Applicant’s Response to Submissions – Proposed Amendment No. 2 to Burswood Lakes Structure Plan

(Updated 15/06/2022)

Schedule of Referral Agency comments – Proposed Amendment No. 2 to Burswood Lakes Structure

Figure 2: North - South Section through Lake Park B-B. Proposed LSP Amendment

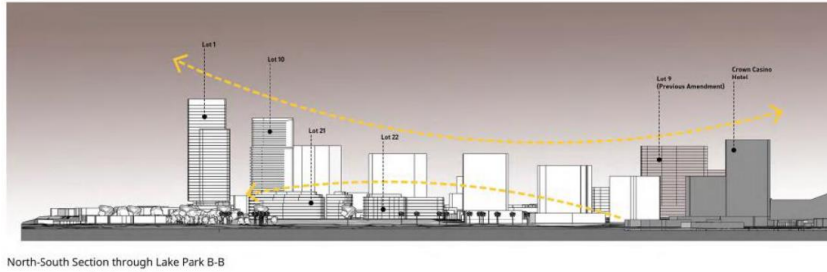
As illustrated in **Figure 2**, the overall context of the 'height arc' is refuted and the tallest proposed building within the structure plan area is proposed on the northern boundary, being Lot 1 (10 storeys higher than Lot 10), in lieu of stepping down, as per the intent of the structure plan. The Structure Plan amendment states the inverted 'height arc' and subsequent increase in height is acceptable given the building height will sit comfortably within the wider Burwood site context when viewed from a distance. However, no consideration is given to the existing building in the immediate area which the majority are constructed.

plan area, notwithstanding, the variation proposed is excessive and the overall principle of the 'height arc' should be retained.

The original 2003 Structure Plan established building heights which were based on a 'height arc' principle with a graduated increase in the height of towers towards the north of the site and then a stepping down. This approach was both design-led and influenced by Perth Airport height limitations applicable at the time which are no longer a restriction.

In terms of the wider site context, the 'height arc' principle has lost its relevance given the changes to the built environment, and the strategic planning that has occurred in the surrounding area. In this new context, the height arc now inverts with high points at Victoria Park Drive and the Crown Towers, as illustrated in 'Amended Figure 2 – Site Section and Elevation' of the Structure Plan Amendment Report.

The submitter states that no consideration is given to the existing buildings in the immediate area which the majority are constructed. This is incorrect. The 2003 bell curve is still relevant for the lower buildings along the western edge providing a transition to the two and three storey scale of the housing on Victoria Park Drive on Lots 2 through to 8 and a transition to the completed three and four storey buildings on Lots 24 and 23 to the south.

Figure 3: Shadow Analysis Diagram. Summer Solstice – December 21 – 3:00PM

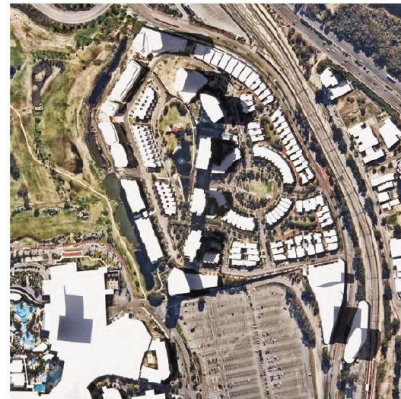
A revised shadow analysis has been prepared to demonstrate the impact of the increased building height, plot ratio and setbacks proposed on Lot 1. The shadow study illustrates that during the winter solstice the single dwellings to the east are unaffected, however during the summer solstice at 3:00pm the majority of Lot [information redacted] Bow River Crescent will be cast in shadow, this includes all north openings to habitable rooms which is critical to the dwelling design due to the zero allotment to the east. It is acknowledged that the shadow analysis has informed the envelope of Lot 1, however Lot [information redacted] is detrimentally impacted.

Issue No. 11: Overshadowing

(Refer to response above). In relation to the submitter’s comment regarding the impact of overshadowing on the adjoining single residential lots to the east of Lot 1, the following is noted. The shadow cast by a building designed in accordance with the height and setback provisions under the original 2003 Structure Plan would still cast a shadow over the adjoining lots during the summer solstice at 3.00pm. Under the proposed Structure Plan Amendment, building setbacks on Lot 1 to Bow River Crescent have been increased to reduce building depth and in doing so, create a more slender east-west orientated building. Whilst this building form produces a longer shadow, the shadow moves more quickly and therefore effects adjoining land for a shorter period of time.

Setbacks along the northern boundary on Lot 1 have also been reduced, which enables the built form to be positioned closer to the northern boundary and in doing so, moves the shadow further north. This increases the extent of shadow cast on the adjoining road reserve (Victoria Park Drive) but reduces the extent of shadow cast on the southern aspect of the adjoining single residential lots to the east.
